## LINCOLN CITY/LANCASTER COUNTY PLANNING STAFF REPORT

for October 27, 2004 PLANNING COMMISSION MEETING

**P.A.S.:** Special Permit #1999A for Community Unit Plan

**PROPOSAL:** To adjust the rear setback down to 0' for Lots 9-23, Block 2, and down to 10' for Lots 8-34, Block 7 for an attached single-family and townhome development of approximately 66 units between Wilderness Hills and Whispering Winds Blvds.

**WILDERNESS HILLS  
TOWNHOUSE EXHIBIT  
LINCOLN, NEBRASKA**

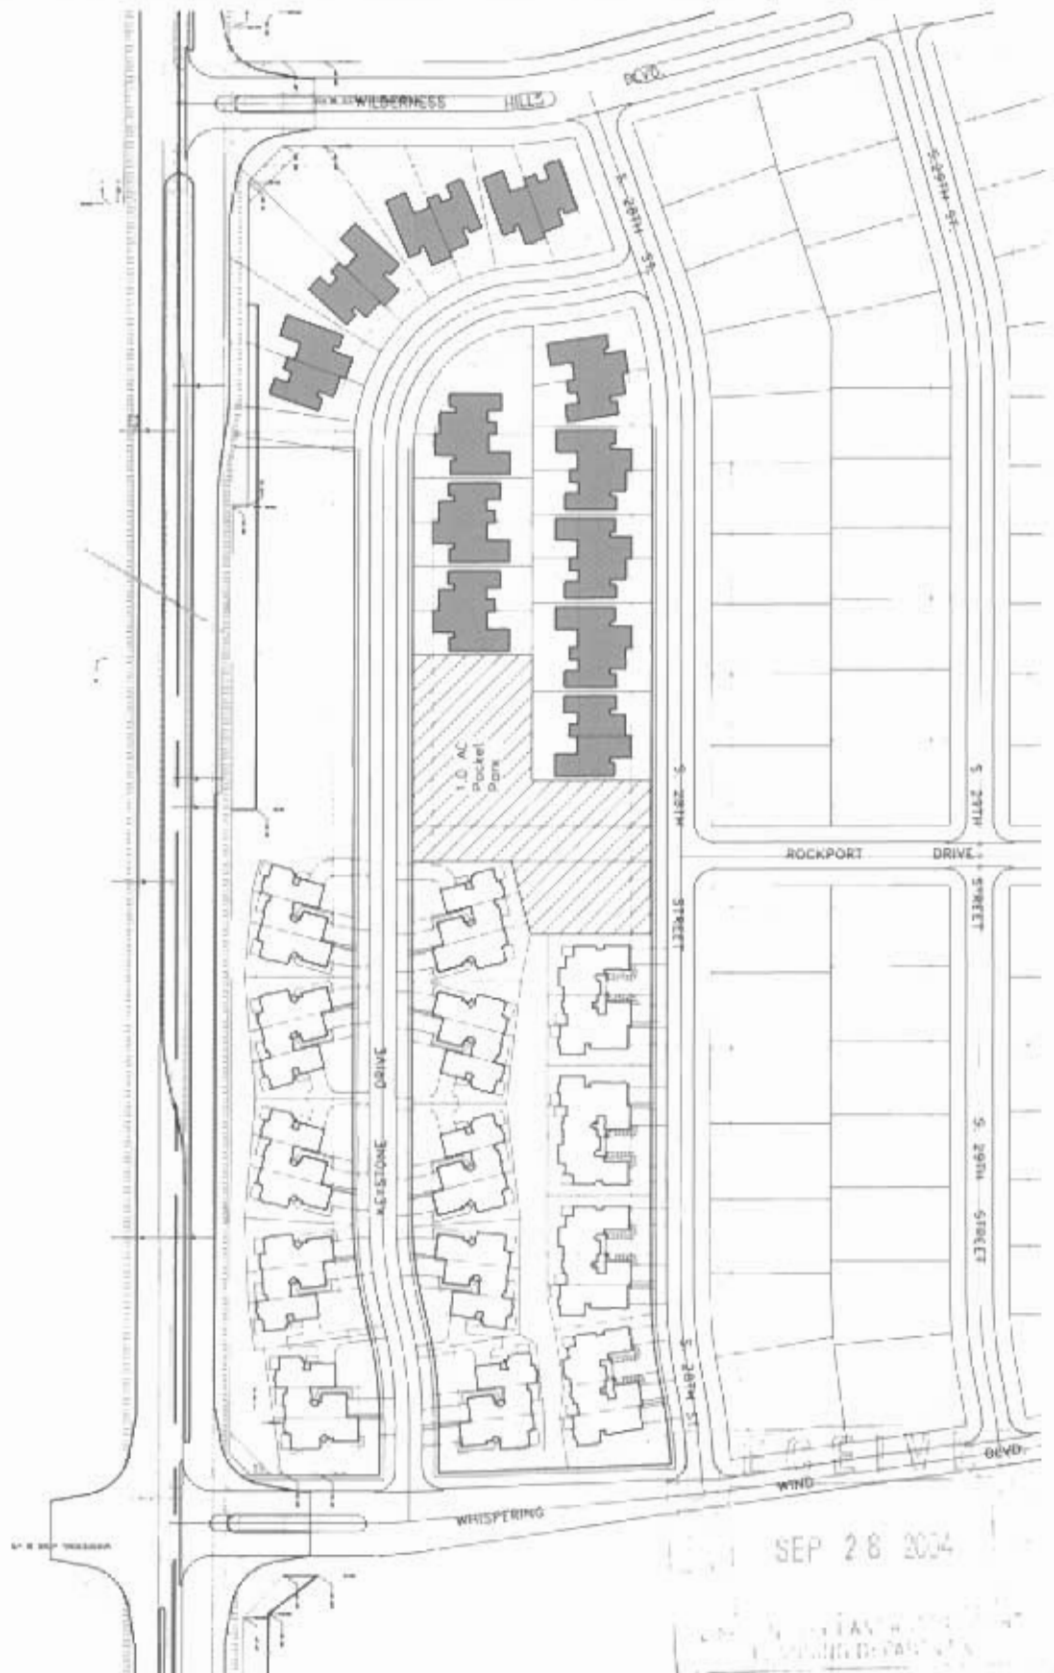
4. To facilitate pedestrian access to the adjacent arterial street sidewalk system, and to the pocket park shown in Outlot D and the open space in Outlot C, a sidewalk should be extended across both Outlots C and D to South 27<sup>th</sup> Street in line with Rockport Drive.

E. Adjust the rear setback for Lots 9-23, Block 2 down to 0', and down to 10' for Lots 8-34, Block 7 - This waiver was not approved as part of the original CUP, and cannot be approved administratively. For Lots 9-23, which are those lots between South 27<sup>th</sup> Street and Keystone Drive, Outlot F separates them from South 27<sup>th</sup> Street. This outlot varies from approximately 15' to 45' in width. The developer is proposing to create this outlot so that a uniform landscape screen can be controlled and maintained along South 27<sup>th</sup> Street. Staff has met with the applicant and is recommending this setback be adjusted to 5' instead of 0'. This will provide a minimum effective setback of 20' from the edge of the South 27<sup>th</sup> Street right-of-way and the townhomes. This is consistent with the front setback in the R-3 and will maintain an adequate separation between the homes and the street in this area.

For Lots 8-34, which are the lots between Keystone Drive and South 28<sup>th</sup> Street, the request is to adjust the rear setback down to 10' to allow for a common open space at the rear of the lots. This open space is in an outlot, and varies in width from approximately 20' to 40'. The setback combined with the outlot serve to provide adequate open space and separation in this area.

7. A landscape screen is required for Lots 5-8, Block 2. Lots 9-23, Block 2 are not adjacent to an arterial street, and a landscape screen is not required. However, as the waiver to the rear setback is requested for Lots 9-23 to provide for a uniformly landscaped area, the site plan should show at least the minimum screening required for lots adjacent to a major street (50% to 6' in height). Additional screening/landscaping can be installed, but this will ensure a minimum amount is provided in Outlot F.

- 1.1.1 Revise the references in General Notes #22 and #23 and in CUP Site Note #7 from "Two-family" to "Single-family Attached."
- 1.1.2 Revise the Waiver Table by deleting waivers #1, #2, #4, and #5, and by amending #6 to note the rear setback for Lots 9-23 is adjusted to 5'.
- 1.1.3 Revise the title of the Waiver Table to read "WAIVER TABLE (CITY OF LINCOLN LAND SUBDIVISION AND ZONING REGULATIONS)."
- 1.1.4 Indicate the purpose of Outlot C, Block 2.

- 1.1.5 Show a sidewalk extending across both Outlots C and D connecting the sidewalk along South 27<sup>th</sup> Street to the sidewalk along South 28<sup>th</sup> Street in line with Rockport Drive.

- 1.1.6 Add Note #10 to CUP Site Notes that reads "THE LANDSCAPE SCREEN ALONG SOUTH 27<sup>TH</sup> STREET WILL MEET OR EXCEED THE REQUIREMENTS OF THE CITY OF LINCOLN DESIGN STANDARDS, CHAPTER 3.5, SECTION 7.4.

- 1.1.7 Show the additional easements per the L.E.S review.
- 1.1.8 Revise the typical street cross sections to include sidewalks.
- 1.1.9 Label the area along South 27<sup>th</sup> Street near the intersection with Wilderness Hills Blvd to be dedicated as right-of-way

- 1.4 The street name change to Keystone Drive must be approved by the Street Name Committee.
- 2. This approval adjusts the rear setback for Lots 9-23, Block 2 to 5', and for Lots 8-34 Block 7 to 10', for Wilderness Hills CUP as shown on the revised site plan.
